STUDY OF APPLICABILITY OF RISK REDUCTION MEASURES IN SPATIAL PLANS

Architektonický ateliér Štěpán – Ing.arch. Václav Štěpán

Version 05/2020

II. Part 2 – pilot locality of Lipí and proposed changes to area planning documentation

Place for solution Čc-2 (village Čakov, cadastral area Čakovec):

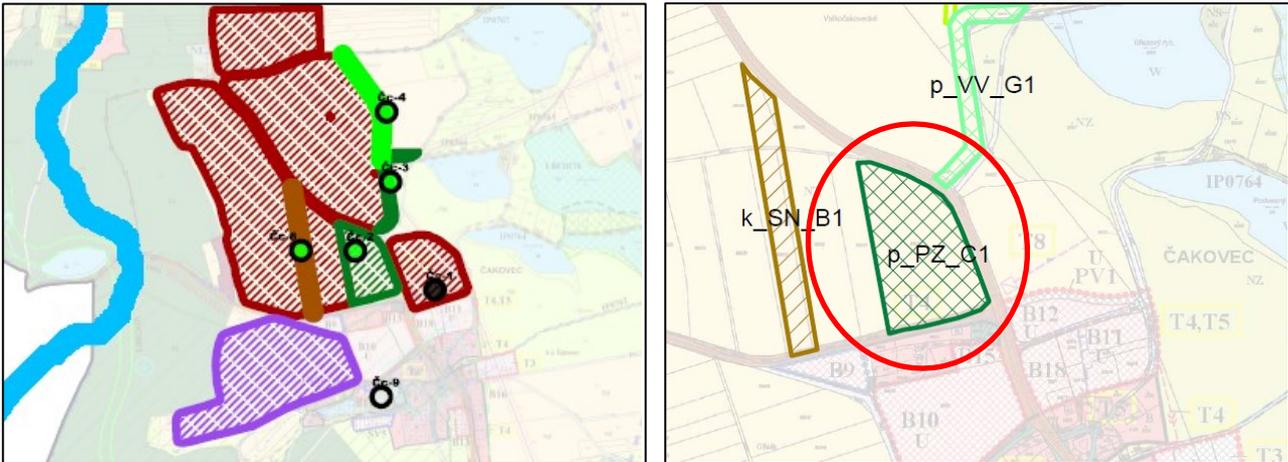
On the territory in the Čakov zoning plan included among the agricultural areas - ZPF arable, the T. G. Masaryk Water Research Institute proposed the implementation of a protective measure in the form of protective grassing. From the assessment of the given area, the processor agrees with the VÚV proposal, he proposed the transformation of arable land into a grassland area, which will enable a better creation of conditions for the implementation of the proposed protective measure. Therefore, for the implementation of the protective measure in question, an agricultural area - permanent grassland (p_PZ_C1) is proposed in the amendment to the zoning plan.

Place for solution Čc-3 (municipality Čakov, cadastral area Čakovec):

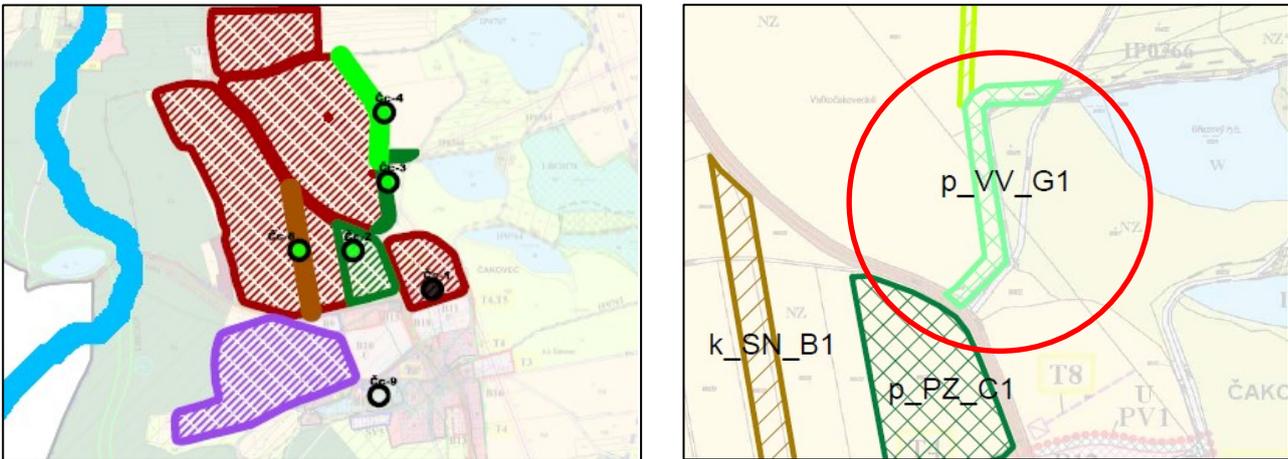
On the territory in the Čakov zoning plan included among agricultural areas - ZPF arable, agricultural areas - ZPF permanent grasslands and water and water management areas - water areas and streams, the T. G. Masaryk Water Research Institute proposed the implementation of a protective measure in the form of protective grassing. However, after assessing the area, the author of this study concluded that a more appropriate solution to the flood risk in this locality would be to modify the flow to a state friendlier to the countryside, especially because some space will be created for landscaping the stream to increase the ability of the environment to slow down the runoff and create floodplains that will reduce the potential consequences of surface runoff. Therefore, for the implementation of the protection measure in question, the water area and the water management area is proposed in the amendment to the zoning plan - modification of the flow line to a state friendlier to the countryside (p_VV_G1).

Place for solution Čc-4 (municipality Čakov, cadastral area Čakovec):

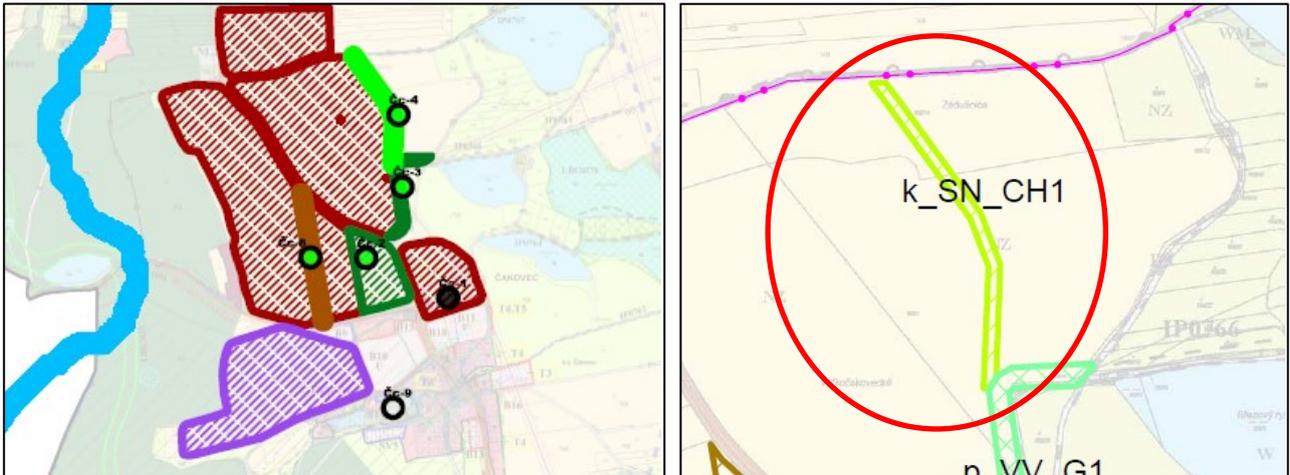
On the territory in the Čakov zoning plan included in the agricultural areas - ZPF arable, the T. G. Masaryk Water Research Institute proposed the implementation of a protective measure in the form of a infiltration belt (stabilization of concentrated runoff paths) to ensure flood protection. After assessing the area, the author of this study agreed with the VÚV proposal, and therefore a mixed corridor of a mixed

undeveloped area - a infiltration belt (k_SN_CH1) is proposed in the amendment of the zoning plan for the implementation of the protection measure in question.

Place for solution Čc-8 (municipality Čakov, cadastral area Čakovec):

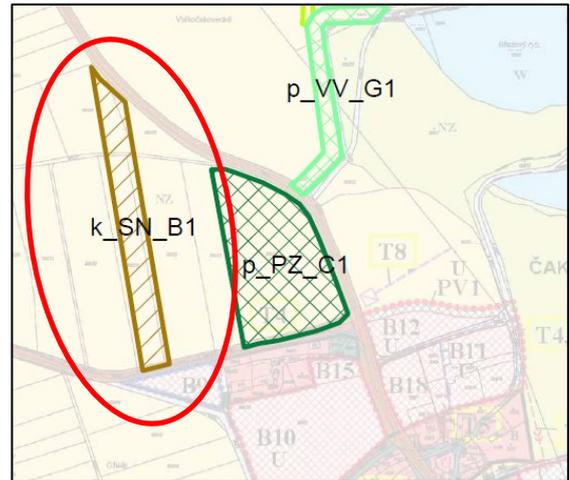
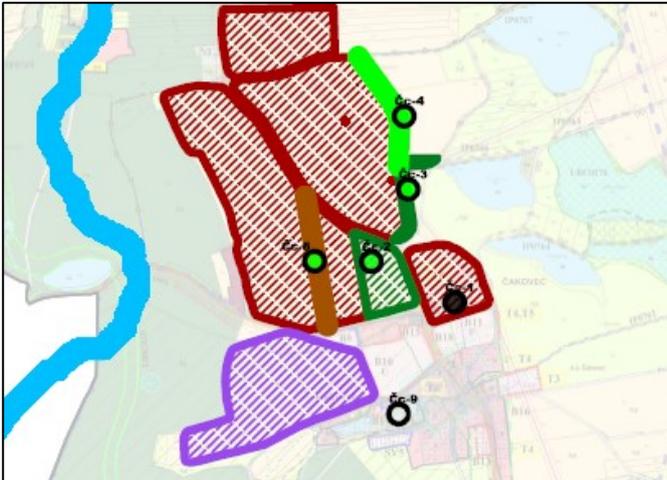
On the territory in the Čakov zoning plan included among the agricultural areas - ZPF arable, the T. G. Masaryk Water Research Institute proposed the implementation of a protective measure in the form of an anti-erosion limit to ensure flood protection. The developer of this study, after assessing the given area, agreed with the VÚV proposal, and therefore a mixed corridor of a mixed undeveloped area - limit (k_SN_B1) is proposed for the implementation of the protection measure in question in the amendment of the zoning plan.

Place for solution Čc-9 (municipality Čakov, cadastral area Čakovec):

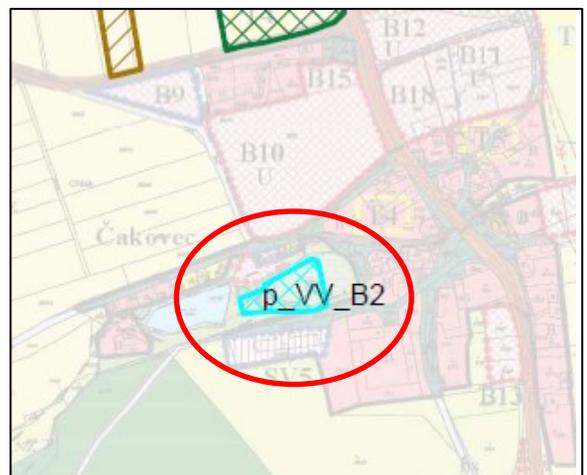
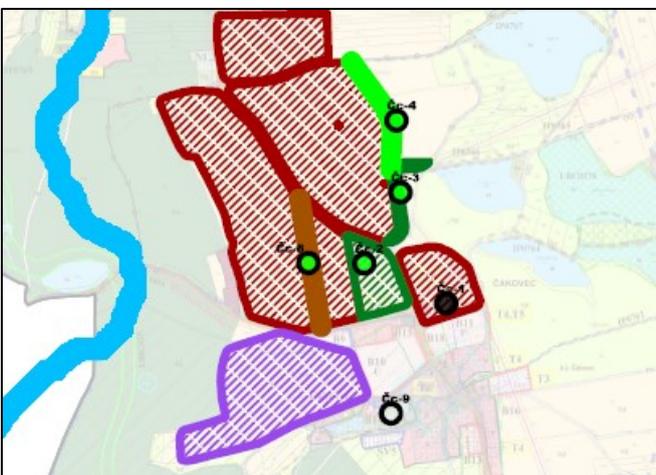
On the territory in the Čakov zoning plan included between water and water management areas - wetlands, the T. G. Masaryk Water Research Institute did not propose the implementation of any protective measures to ensure flood protection. However, after preparing the area, the author of this study concluded that in order to reduce the flood risk in this locality, it is appropriate to supplement the flood protection measures with a new small reservoir, mainly due to the addition of another possible water area with an auxiliary function, when capturing storm water flowing into this place from the surrounding hills. This water area is also designed with regard to the requirements of the municipality, which in these places is struggling with the accumulation of torrential precipitation which further proceeds through the creek bed to the centre of the municipality. Therefore, for the implementation of the protective measure in question, a water and water management area - a small water reservoir (p_VV_B2) is proposed in the amendment to the zoning plan.

Place for solution Čc-10 (municipality Čakov, cadastral area Čakovec):

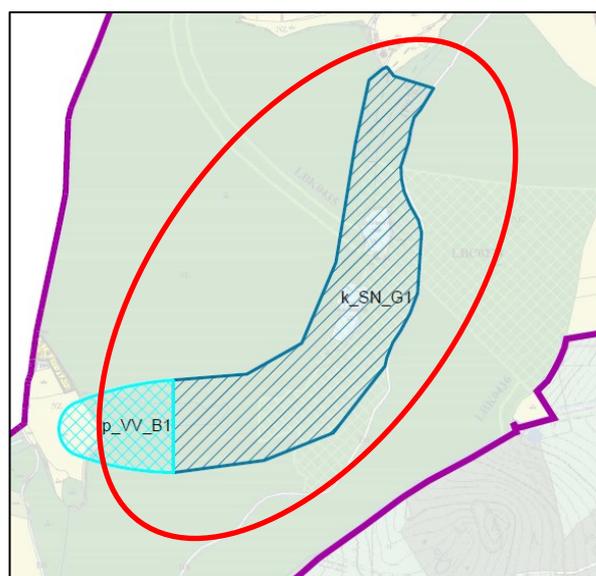
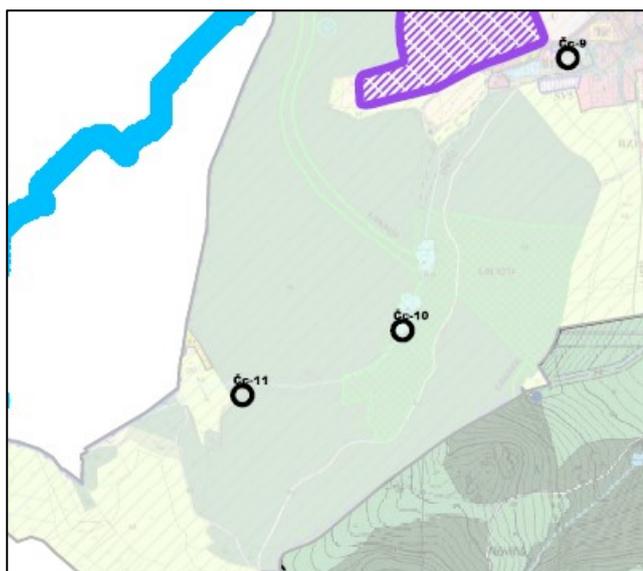
On the territory in the Čakov zoning plan included among water and water management areas - water areas and streams and forest areas (the territory also passes elements of the local system of ecological stability LBC0274 and LBK0435) However, after assessing the area, the author of this study concluded that in order to reduce the flood risk in this locality, it is appropriate to supplement the flood protection system with a system of dams, mainly due to the creation of a corridor for new flood protection elements located in forest lands. The system of dams is designed mainly due to the slowing down of the outflow of storm water, its regulation and partial retention on forest land. Therefore, for the implementation of the protective measure in question, a mixed corridor of a mixed undeveloped area - a system of dams (k_SN_G1) is proposed in the amendment to the zoning plan.

Place for solution Čc-11 (village Čakov, cadastral area Čakovec):

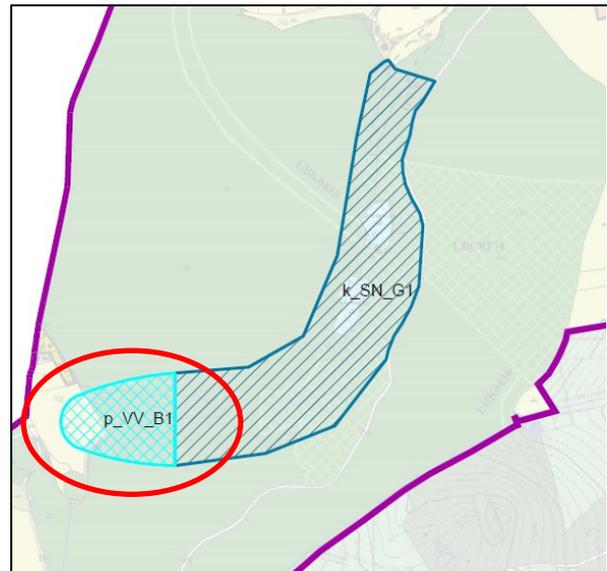
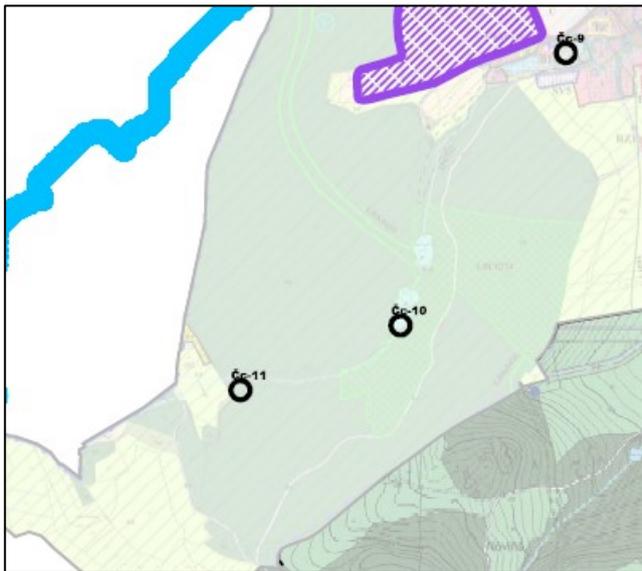
On the territory in the Čakov zoning plan included among water and water management areas - water areas and streams, forest areas, mixed undeveloped areas - lands of natural and nature-friendly ecosystems and agricultural areas - ZPF did not design permanent grasslands to ensure flood protection T. G. Masaryk Water Research Institute implementation of any protective measure. However, after assessing the area, the author of this study came to the conclusion that in order to reduce the flood risk in this locality, it is appropriate to supplement flood control measures with a small reservoir, especially due to the capture of rainwater and storm water in forest land, the creation of a cooperating biological element in landscape, which will help, in the event of a drought, by bringing water to the surrounding landscape and creating a quality microclimate. Therefore, for the implementation of the protective measure in question, a water and water management area - a small water reservoir (p_VV_B1) is proposed in the amendment to the zoning plan.

Place for solving Kv-1 (village Kvítkovice, cadastral area Kvítkovice):

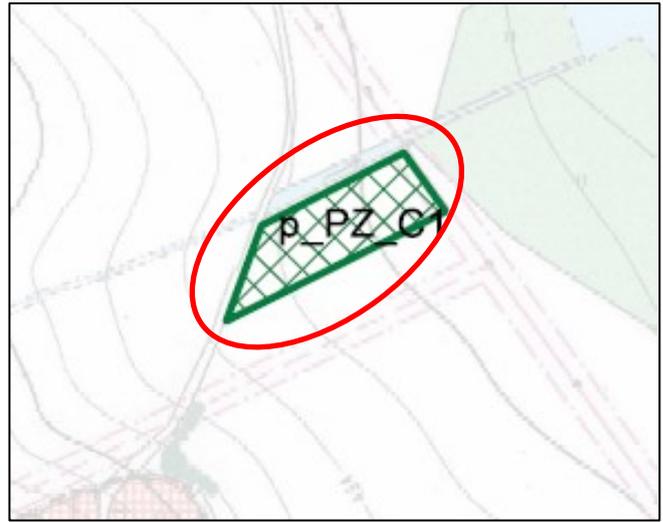
On the territory in the Kvítkovice zoning plan included among agricultural areas, the T. G. Masaryk Water Research Institute proposed the implementation of a protective measure in the form of protective grassing. During the assessment of the given area, the author proposed the conversion of arable land into an area of permanent grassland, which will enable a better creation of conditions for the implementation of the proposed protective grassing. This is only a part of the proposed area according to the VÚV, because the part adjacent to the water area is already in the area - meadows and pastures. Therefore, for the implementation of the protective measure in question, the area of the measure - agricultural area - permanent grassland (p_PZ_C1) is proposed in the amendment to the zoning plan.

Place for solving Kv-2 (village Kvítkovice, cadastral area Kvítkovice):

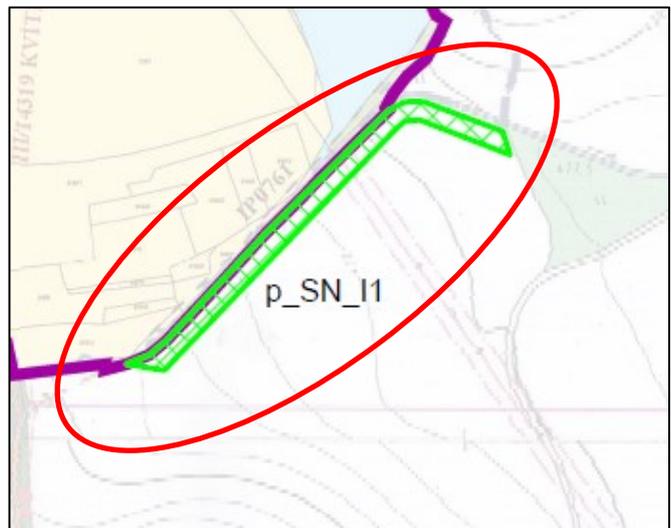
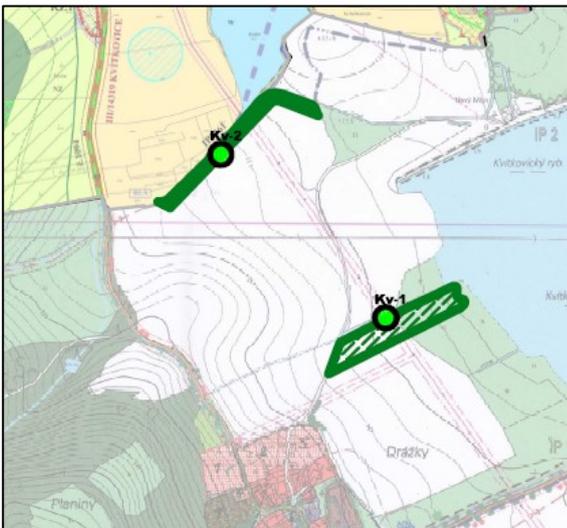
On the territory in the Kvítkovice zoning plan included among agricultural areas, the T. G. Masaryk Water Research Institute proposed the implementation of a protective measure in the form of protective grassing. However, after assessing the area, the author of the study concluded that a more appropriate solution to the flood risk in this locality would be to stabilize the concentrated runoff paths, mainly because space will be created for landscaping the stream to increase the ability of the environment to slow down runoff and create runoff flood zones, which will reduce the potential consequences of surface runoff. Therefore, for the implementation of the protection measure in question, a mixed area of undeveloped area - grassing of the valley (p_SN_I1) is proposed in the amendment to the zoning plan to ensure stabilization of the concentrated runoff path.

Place for solving Kv-3 (village Kvítkovice, cadastral area Kvítkovice):

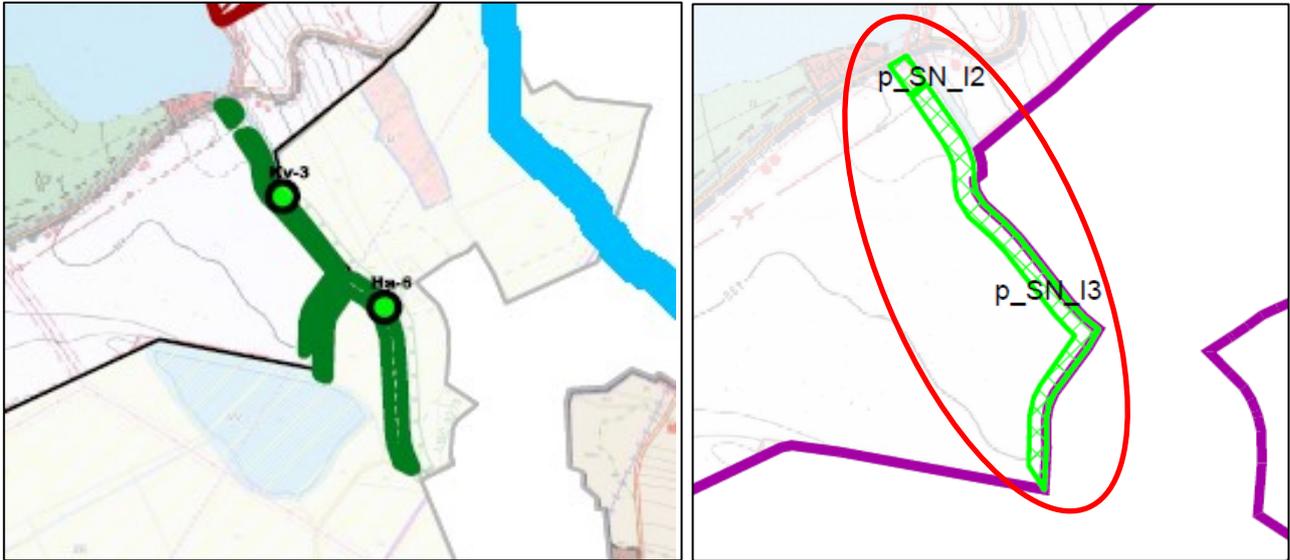
On the territory in the Kvítkovice zoning plan included among agricultural areas, the T. G. Masaryk Water Research Institute proposed the implementation of a protective measure in the form of protective

grassing. However, after assessing the area, the author of the study concluded that a more appropriate solution to the flood risk in this locality would be to stabilize the concentrated runoff paths, mainly because space will be created for landscaping the stream to increase the ability of the environment to slow down runoff and create runoff. flood zones, which will reduce the potential consequences of surface runoff. Therefore, for the implementation of the protection measure in question, a mixed area of undeveloped area - grassing of the valley (p_SN_I2, p_SN_I3) is proposed in the amendment to the zoning plan to ensure stabilization of the concentrated runoff path.

Place for solution Kv-4 to Kv-6 (village Kvitkvice, cadastral area Kvitkvice):

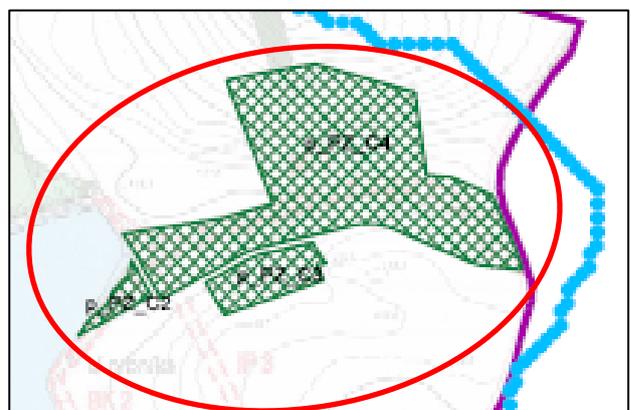
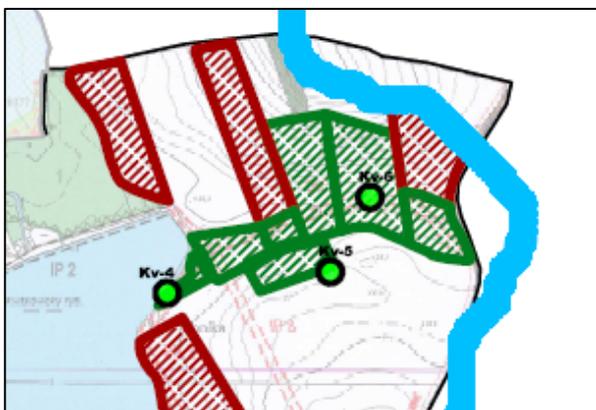
On the territory in the Kvitkvice zoning plan included among agricultural areas, the T. G. Masaryk Water Research Institute proposed the implementation of a protective measure in the form of protective grassland to ensure flood protection. From the assessment of the given area, the processor agrees with the VÚV proposal, therefore he proposed the conversion of arable land into an area of permanent grassland, which will enable a better creation of conditions for the implementation of the proposed protective grassing. For the implementation of the protective measure in question, the areas of the measure - agricultural areas - permanent grassland (p_PZ_C2, p_PZ_C3, p_PZ_C4) are proposed in the amendment to the zoning plan.

Places to solve Ha-3 and Ha-4 (Habří municipality, Habří u Lipí cadastral area):

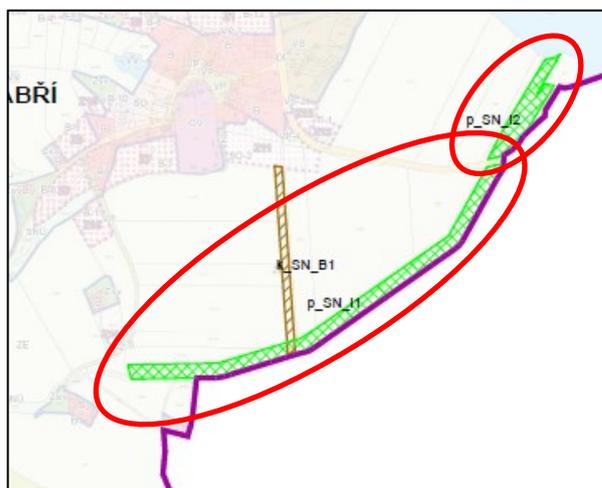
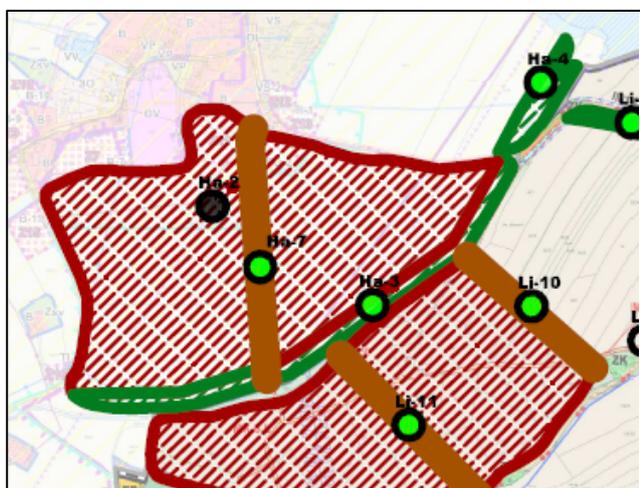
On the territory in the Habří zoning plan included among agricultural areas, the T. G. Masaryk Water Research Institute proposed the implementation of a protective measure in the form of protective grassland to ensure flood protection. However, after assessing the area, the author of this study came to the conclusion, that a more suitable solution to the flood risk in this locality would be to stabilize the concentrated runoff paths, mainly due to easier and more accurate management of water runoff from the surrounding terrain. Specifically, it is a modification of the vegetation in the immediate vicinity of the stream, stabilization of the riverbed or modification of the accompanying riparian vegetation. Therefore, for the implementation of the protection measure in question, mixed areas of undeveloped area - grassing of the valley (p_SN_I1 and p_SN_I2) are proposed in the amendment to the zoning plan.

Place for solving Ha-7 (village Habří, cadastral area Habří u Lipí):

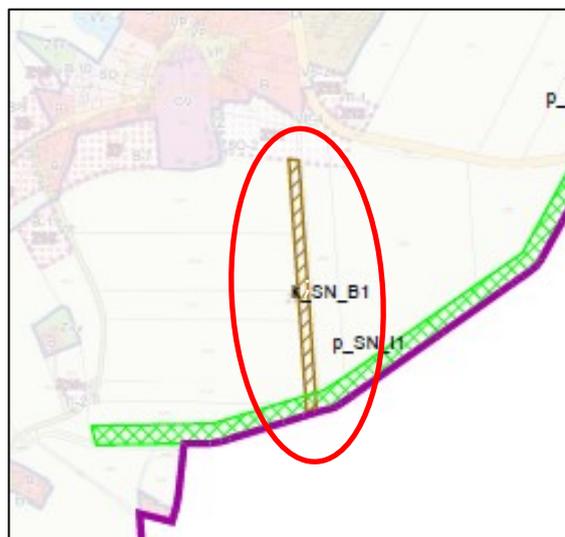
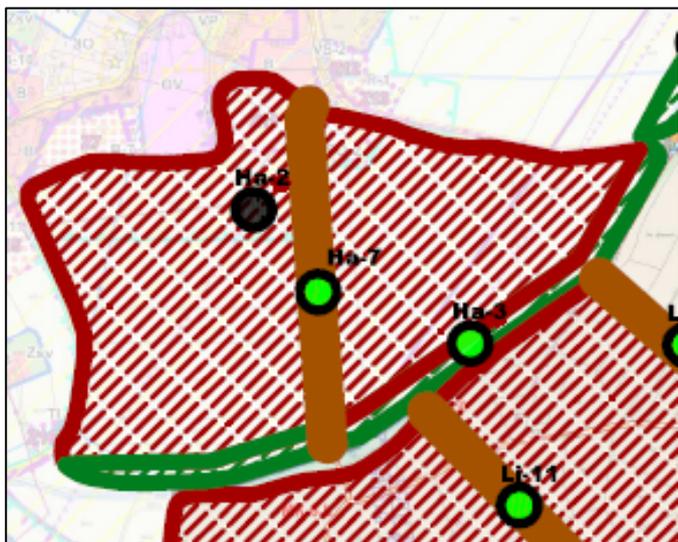
On the territory in the Habří zoning plan included among agricultural areas, the T. G. Masaryk Water Research Institute proposed the implementation of a protective measure in the form of an anti-erosion field border to ensure flood protection. The author of this study, after assessing the given area, agreed with the VÚV proposal, and therefore, for the implementation of the protective measure in question, a mixed corridor of a mixed undeveloped area - limit (k_SN_B1) is proposed in the amendment of the zoning plan.
